**City of Biddeford
Planning Board**

November 20, 2024 at 6:00 PM
City Hall Council Chambers & Zoom

- 7.c 2024.59 The Planning Board will review a Preliminary Subdivision Plan for Acorn Engineering on behalf of 1921 Pepperell, LLC to redevelop buildings 19 & 20 of the Pepperell Mills into 64 residential units with utility infrastructure improvements. The property is located at 6, 32-40 Main Street (Tax Map 71, Lots 10-7, 10-4 & 10-1) in the MSRD-3 & Shoreland Overlay Zone.

7.e 2023.29 The Planning Board will review a request for Preliminary Approval for 209 condos in Phase I from One Diamond, LLC. The location of the property is considered 1 Diamond Street with the subdivision running from Elm Street to Main Street further identified as tax map 40, lots 25-2, 25-2, 24. 25 & 74; tax map 37, lots 34 & 35 in the MSRD-3 Zone.

SHEET C-303

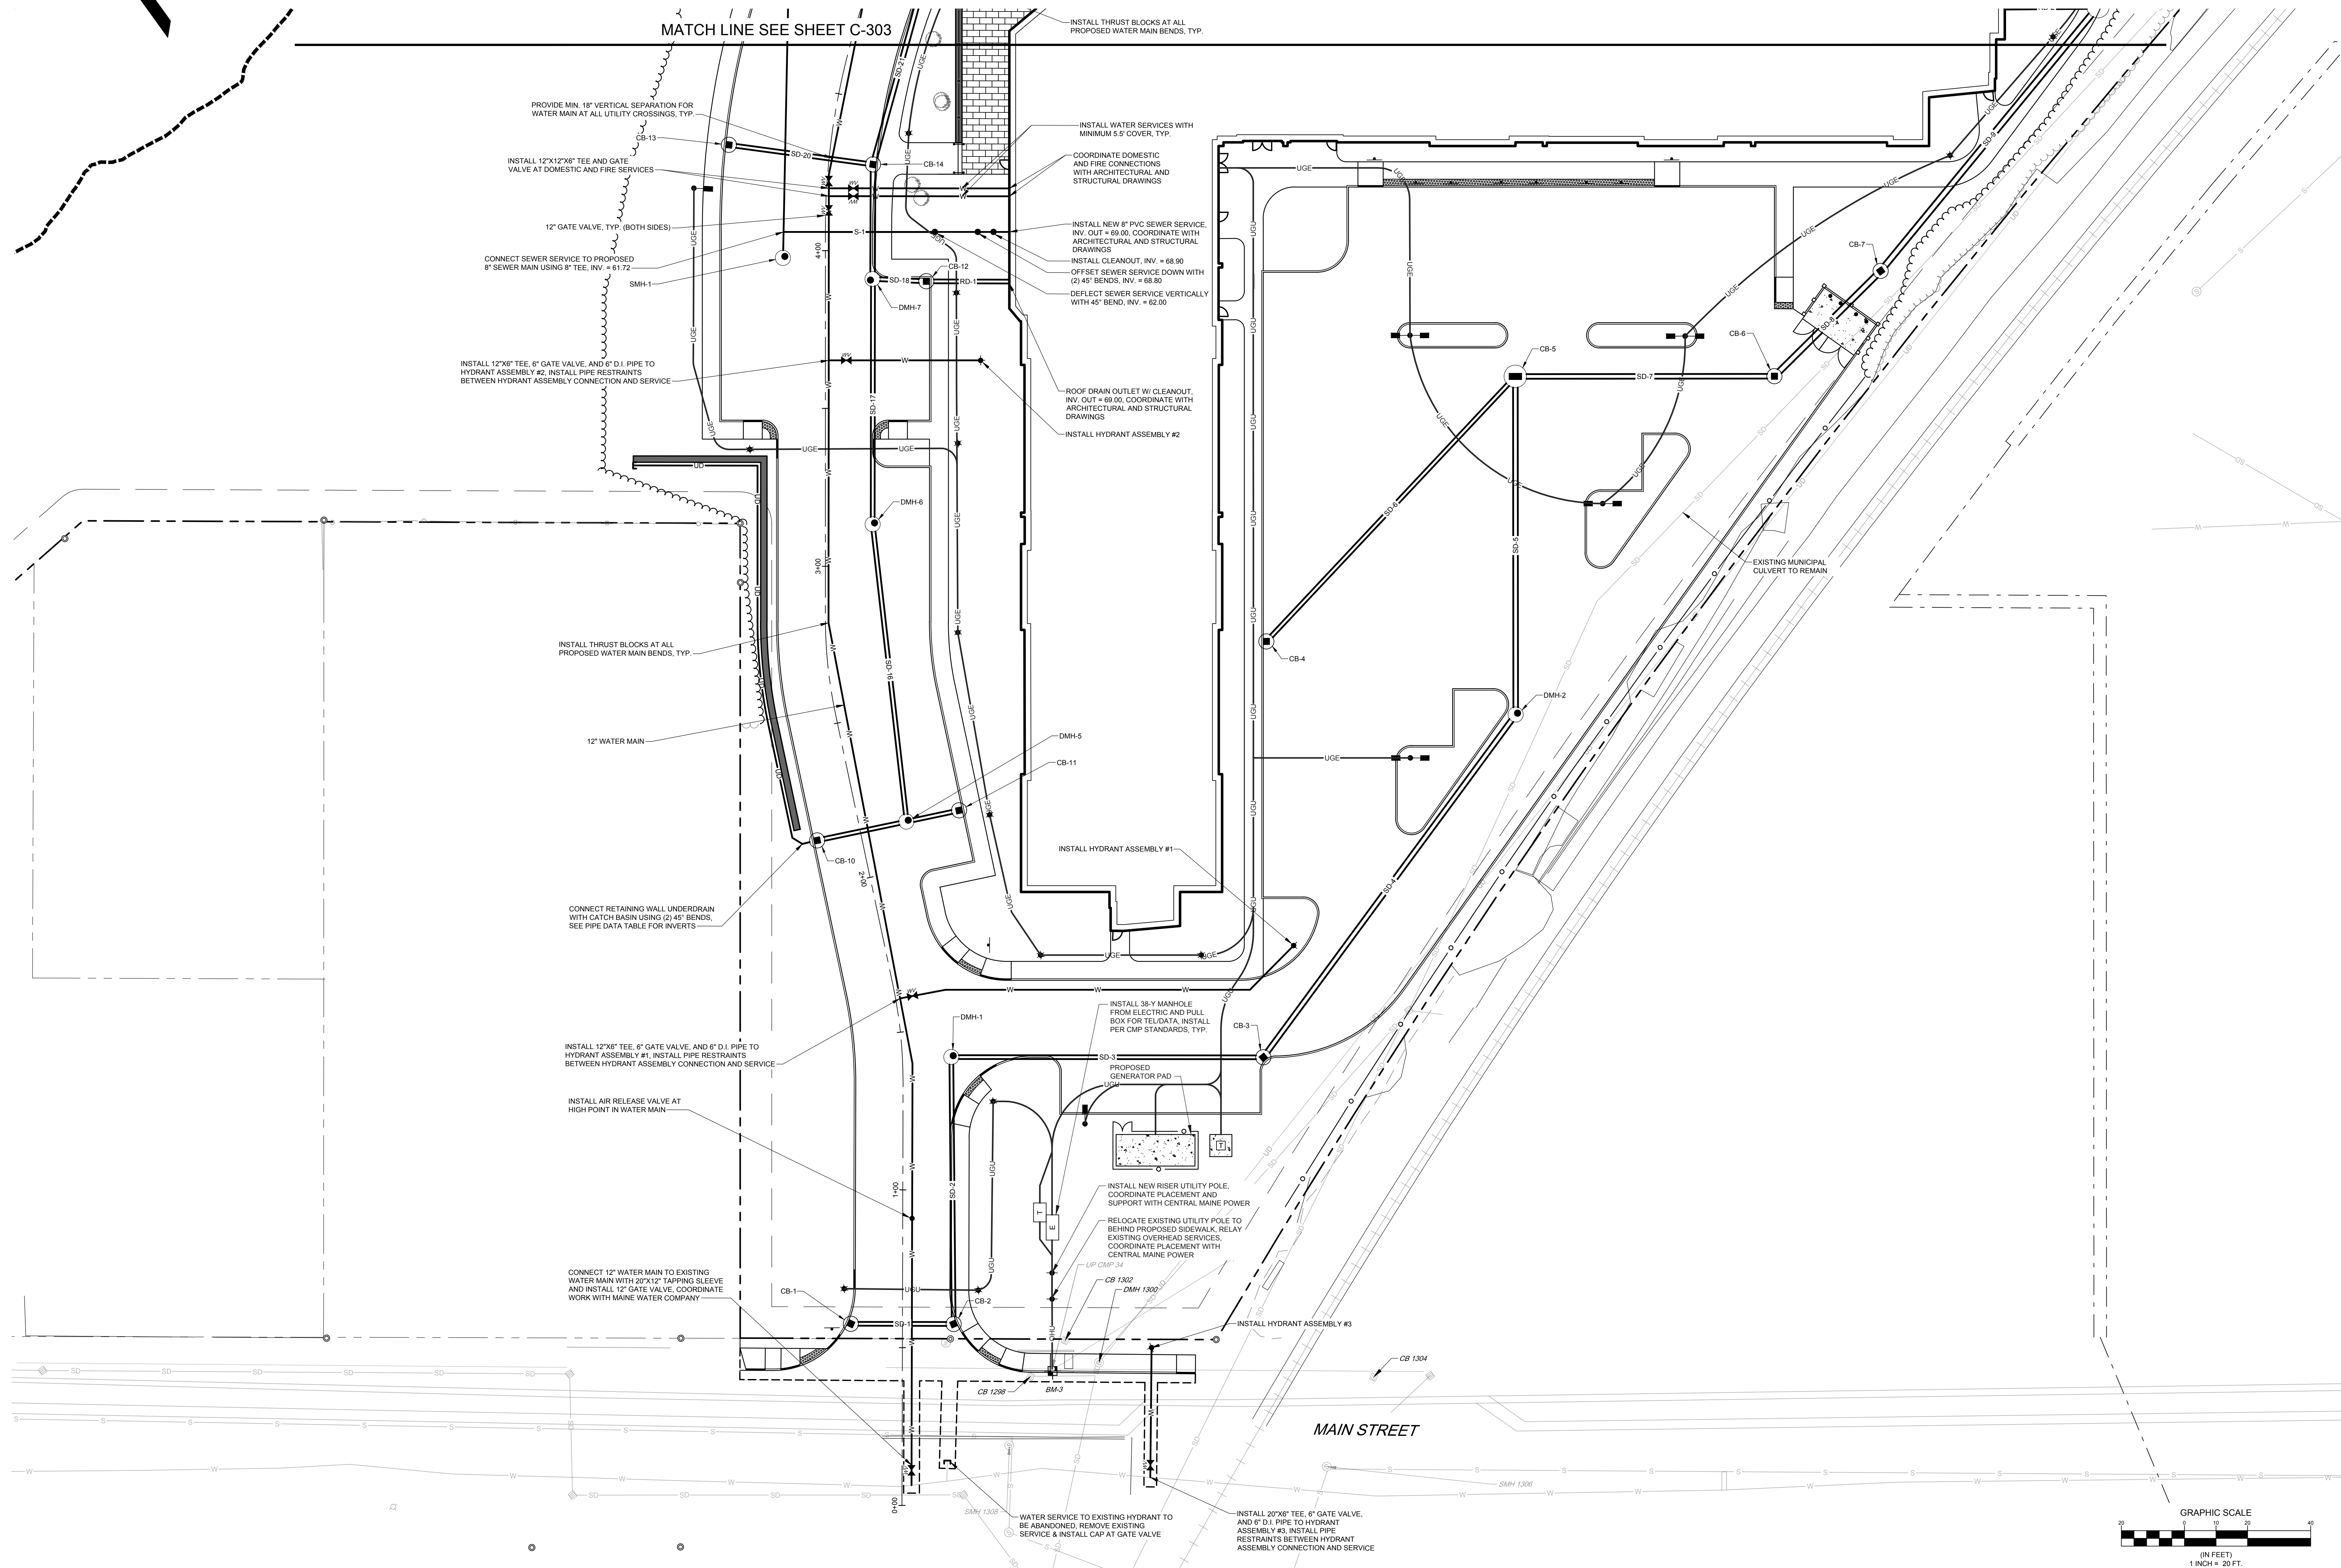
Sheet C-303 has been revised to add callouts clarifying that the existing 12" sewer will be redirected at existing manhole ESMH-1265 to the new 60" sewer at proposed manhole SMH-2. Once this connection is made, the existing 12" sewer running westerly along the river from ESMH-1265 to Horrigan Court will be plugged and abandoned in place.

Information on this sewer replacement is now presented on revised sheet C-303, with profiles on C-310 and C-311.

SHEET C-309

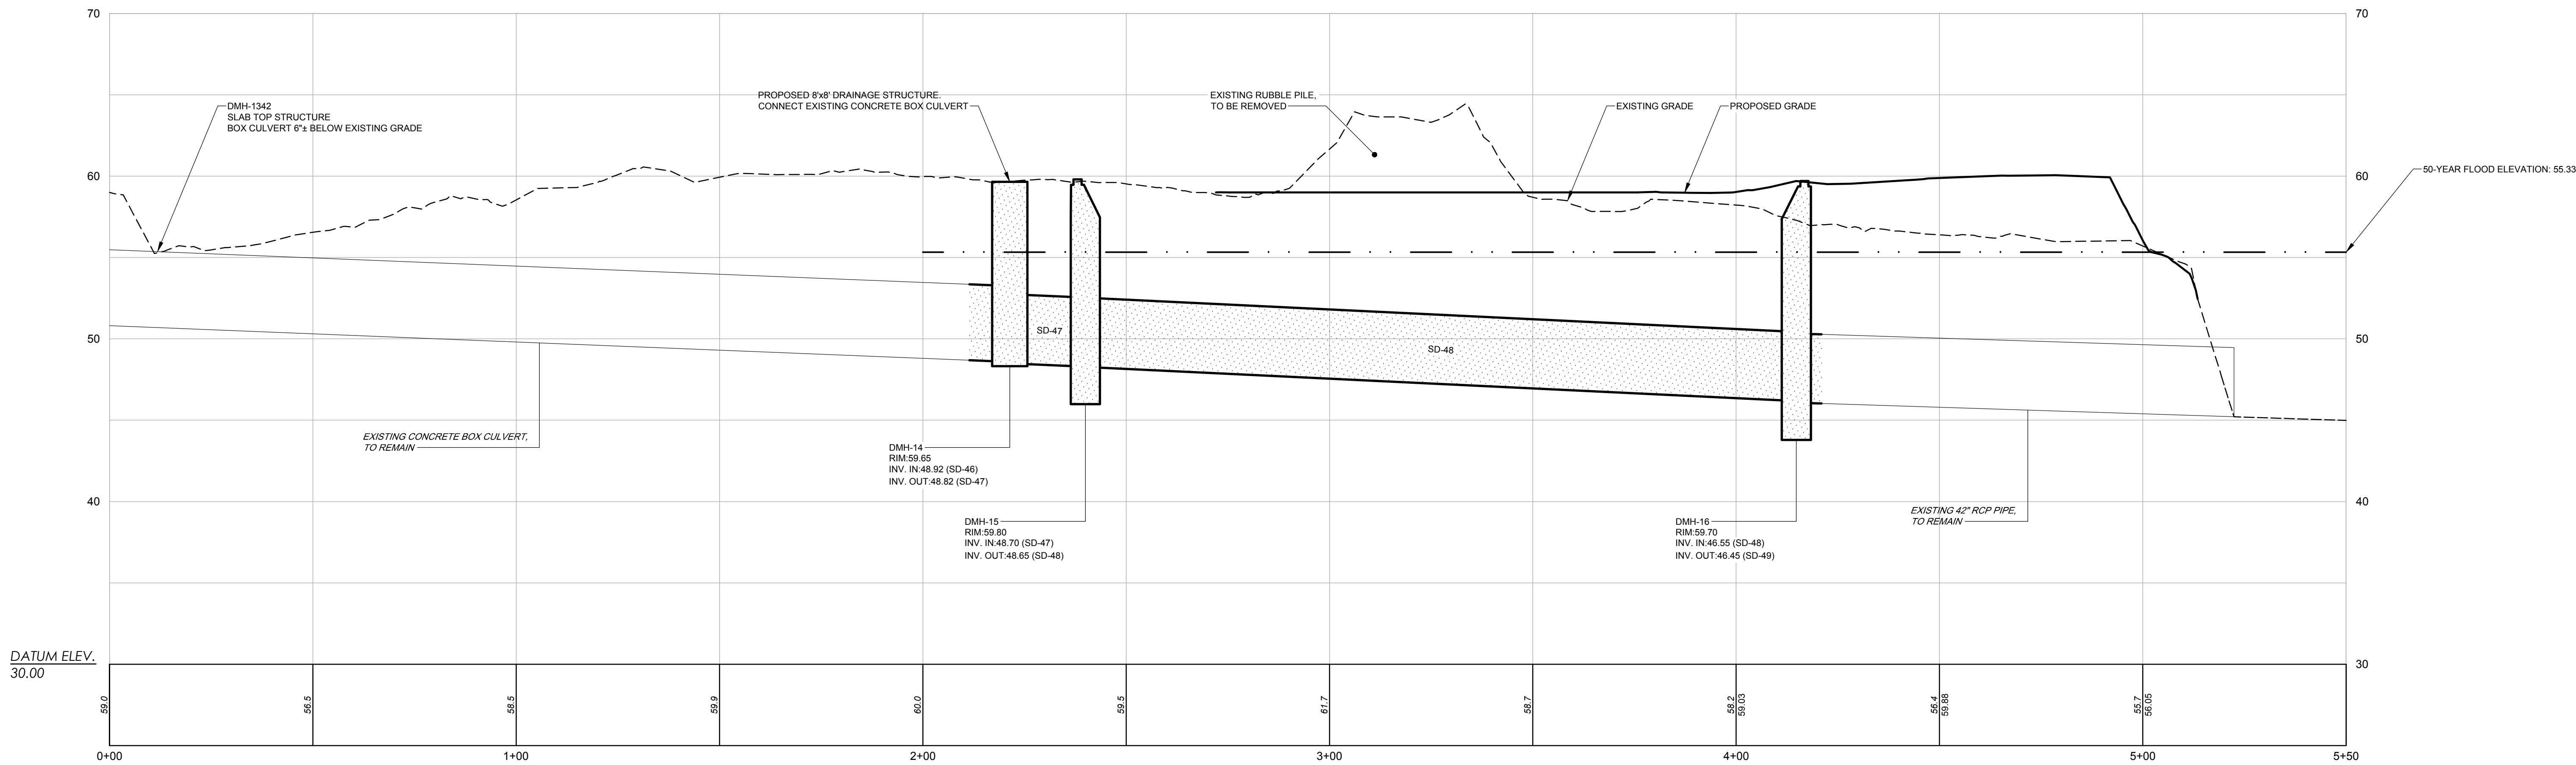
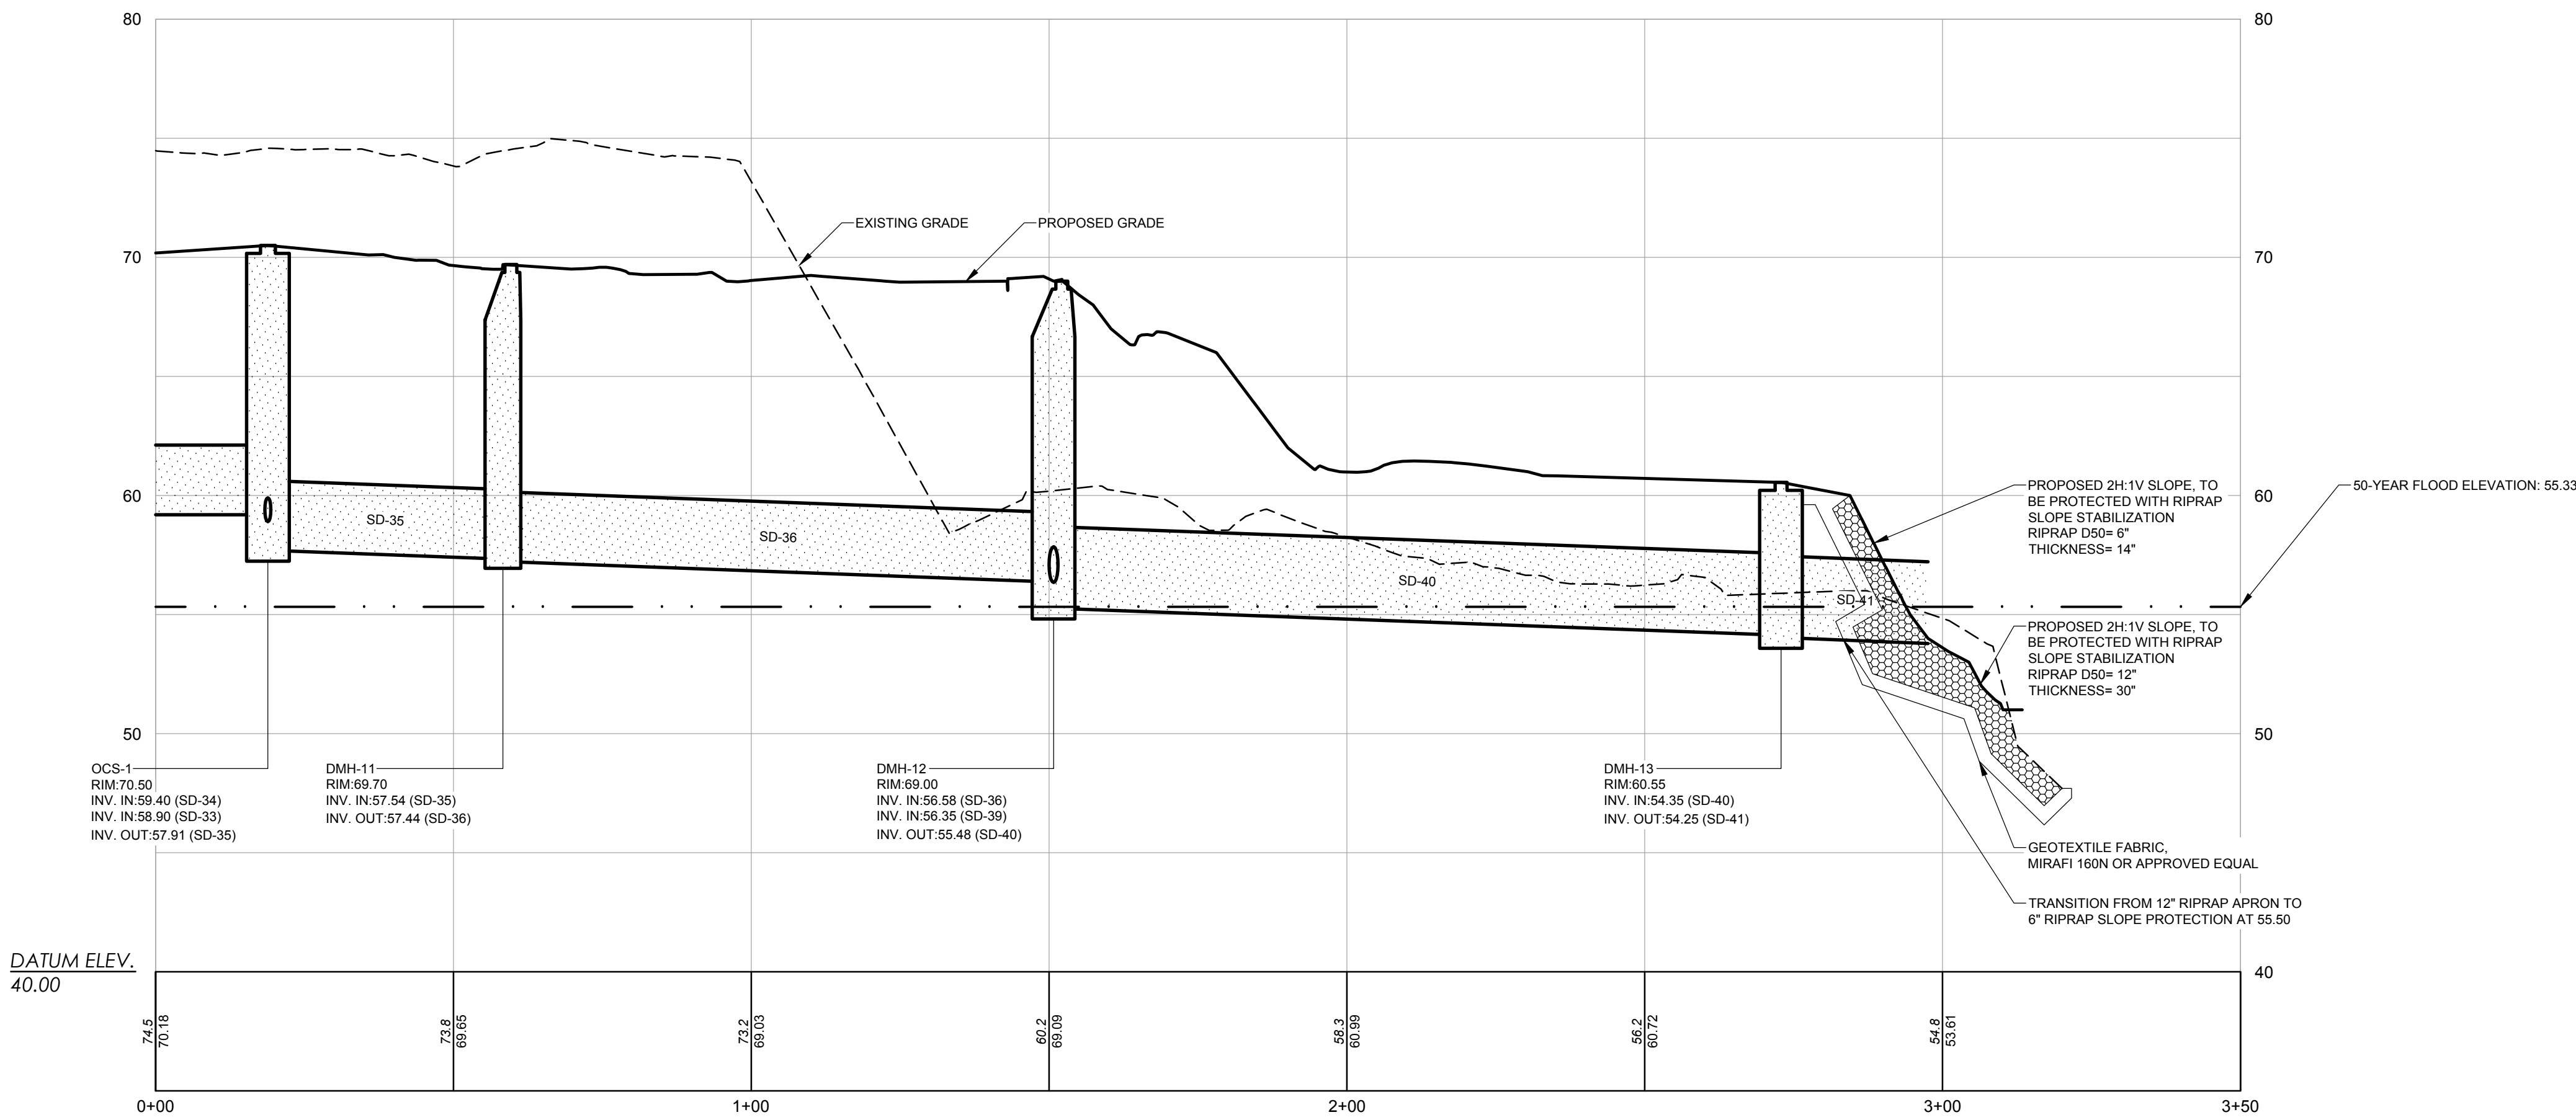
The revised plan set now includes profiles for utility main-line runs. The stormwater outfall is shown on Sheet C-309 the remaining utility profiles are presented on sheets C-306 through C-311.
